REVISED MT. ZION BAPTIST CHURCH SUBDIVISION

APPLICATION NUMBER 10 DATE June 2, 2011

APPLICANT Revised Mt. Zion Baptist Church Subdivision

REQUEST Subdivision

DETAIL SITE PLAN

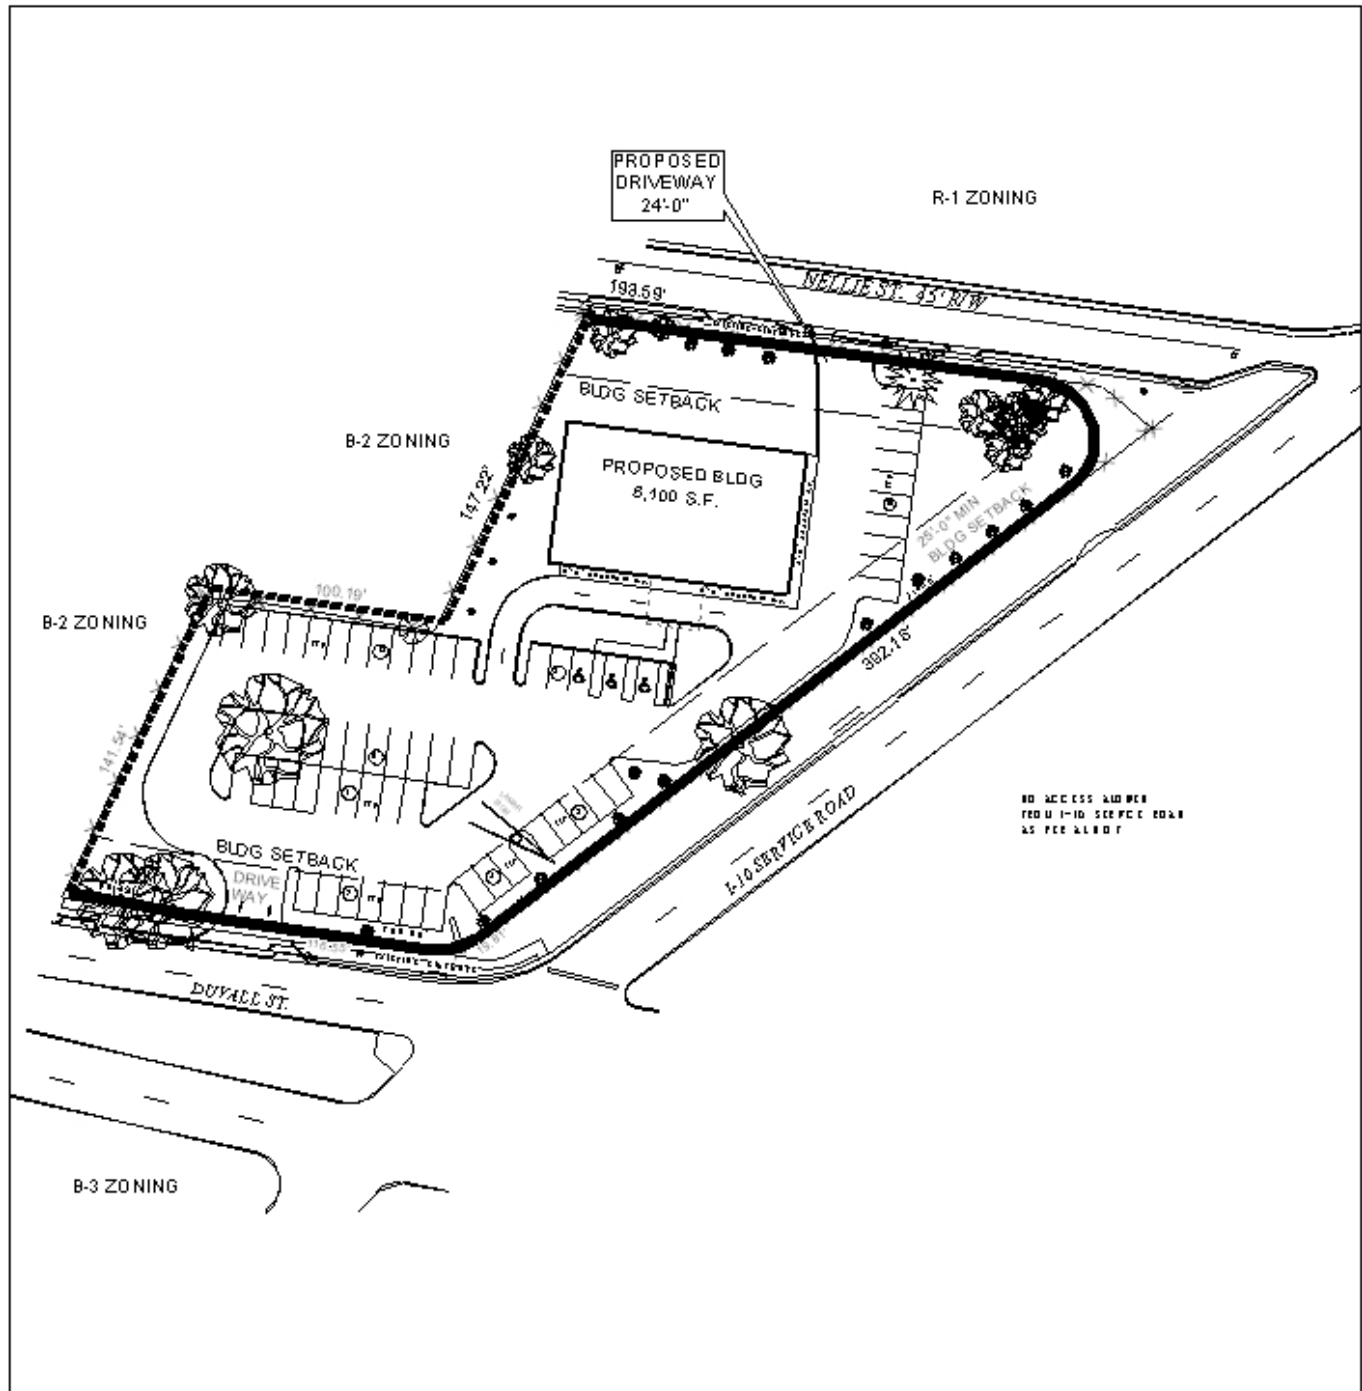
Traffic Engineering Comments: Driveway number, size, location, and design to be approved by Traffic Engineering and conform to AASHTO standards. Proposed driveway should be realigned to remove the skew intersection with Nellie Street.

The proposed lot, as depicted, meets the minimum size and frontage requirements as regulated by the Subdivision Regulations. The lot area size is not depicted on the plat in square feet, and this should be shown on the Final Plat, if approved. The 25-foot minimum building setback line is shown along all rights-of-way, and this should be retained on the Final Plat, if approved.

Traffic Engineering and conform to AASHTO standards. It should be noted that Duval Street is noted at "Duvall Street" on the preliminary plat, and this spelling should be corrected on the Final Plat, if approved.

- 5) compliance with Traffic Engineering comments: *"Proposed driveway should be realigned to remove the skew intersection with Nellie Street;"*
- 6) correction of the spelling of Duval Street;

- 1) labeling of the lot area size in square feet;
- 2) retention of the 25-foot minimum building setback line along all public rights-of-way;
- 3) placement of a note on the Final Plat stating that the lot is denied access to the I-10 Service Road;

- 4) placement of a note on the Final Plat stating that the lot is limited to one curb cut each to Nellie Street and Duval Street, with the size, design, and exact location of all curb cuts to be approved by Traffic Engineering and conform to AASHTO standards;
